Revision #: 1

Landscape Plan:

Ashes Dr. Office Bldg.

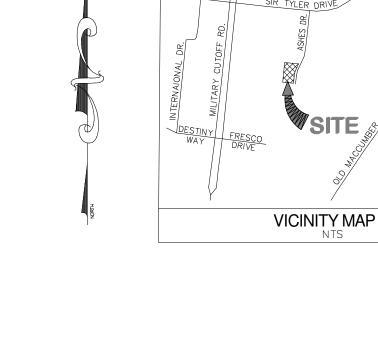
These are street trees & may not be allowed by CFPUA since they are over a 8" water main.
